OXFORD AV, RESIDENCES
 PRECAST SLAB
 N | : 300
 30/5/2019

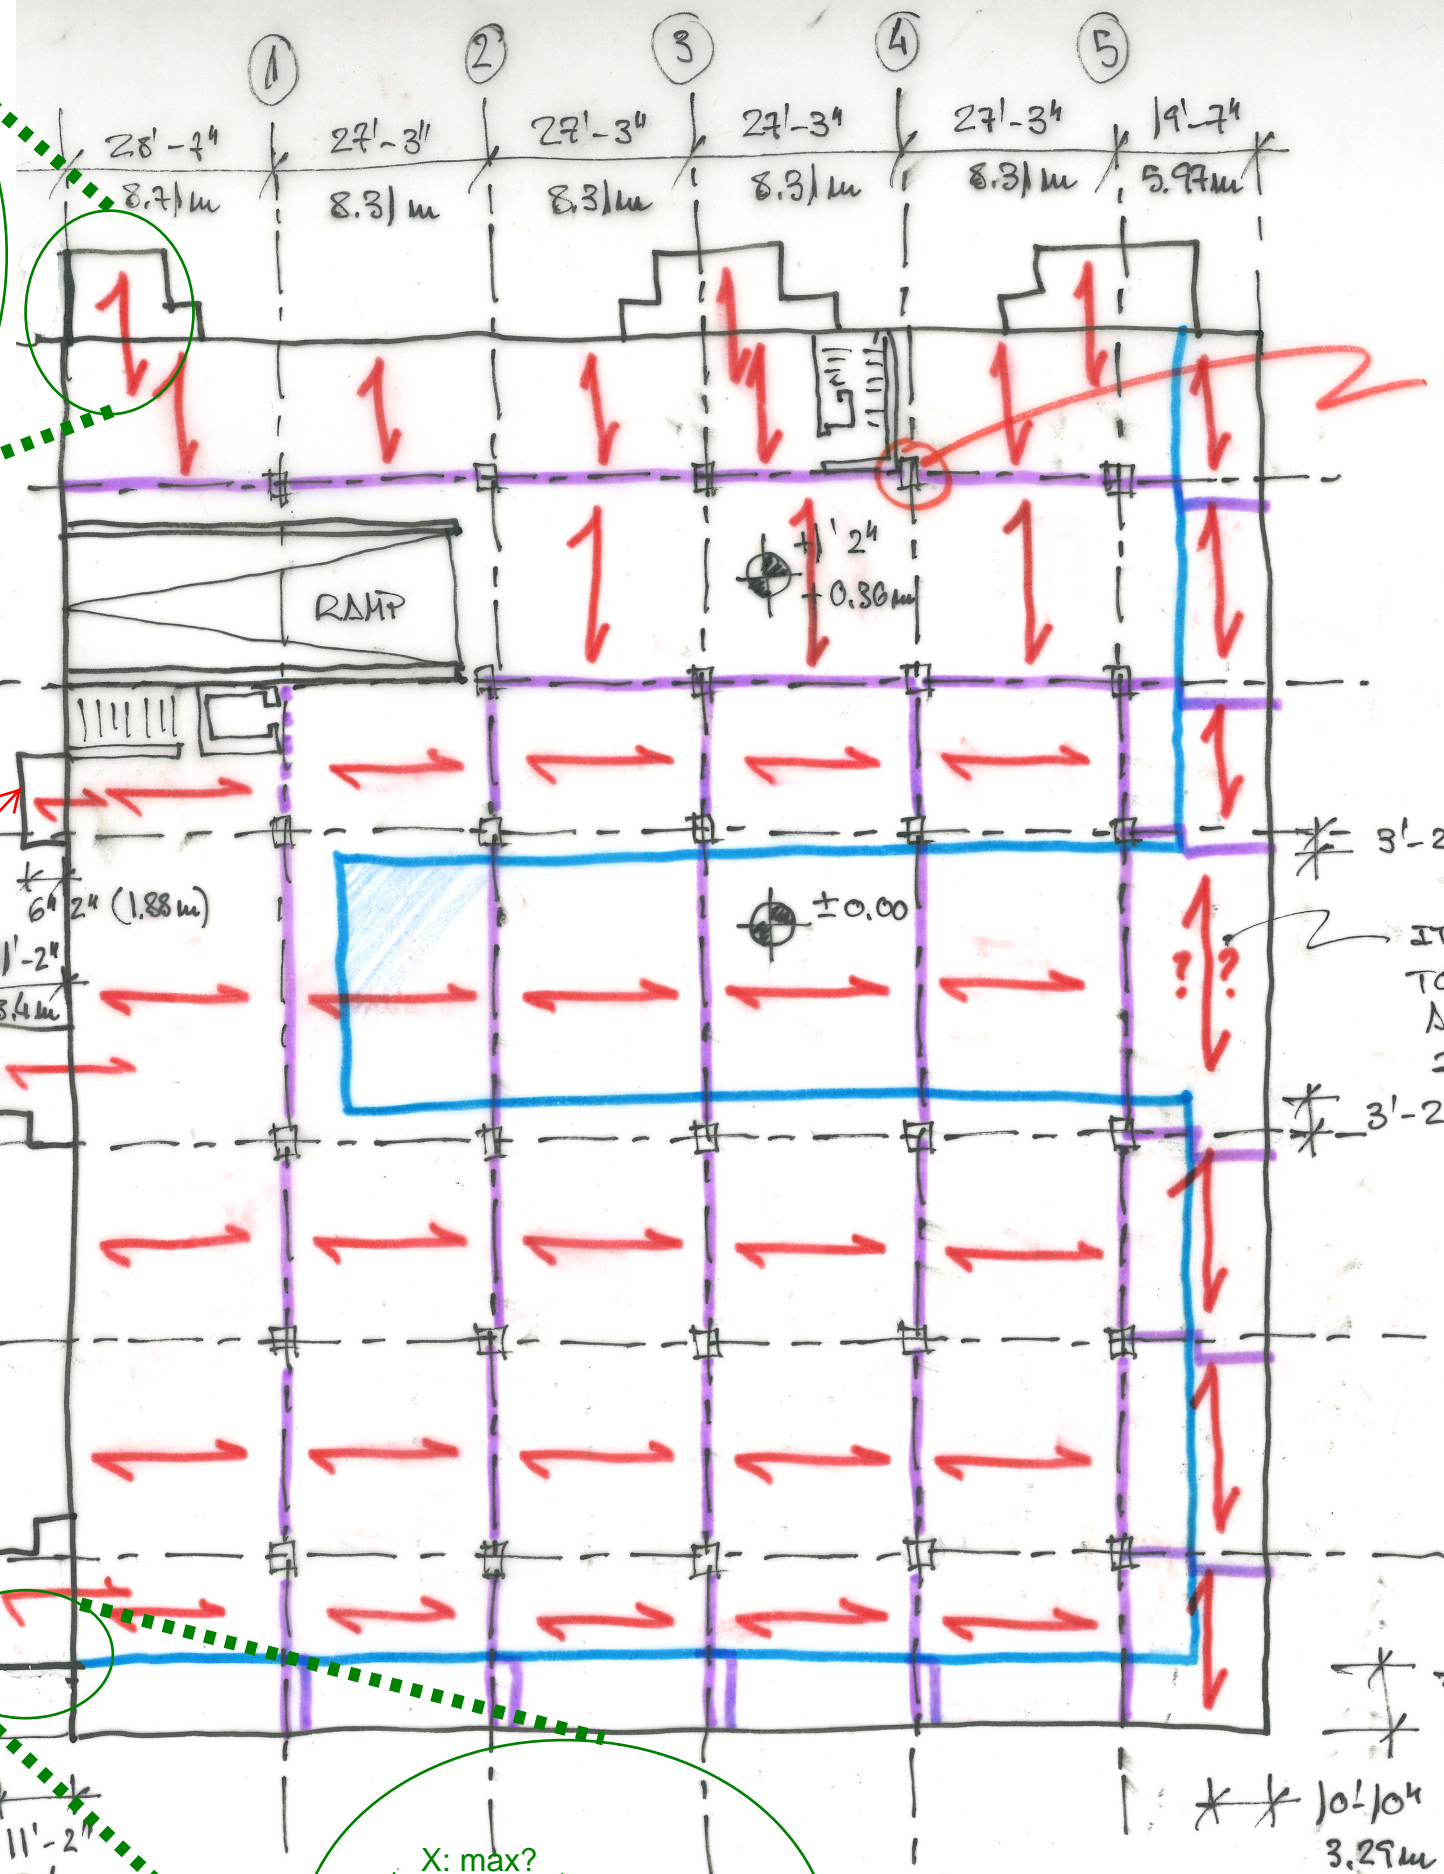
6' cantilever will require solid slab.

Span is too long for plank to cantilever.
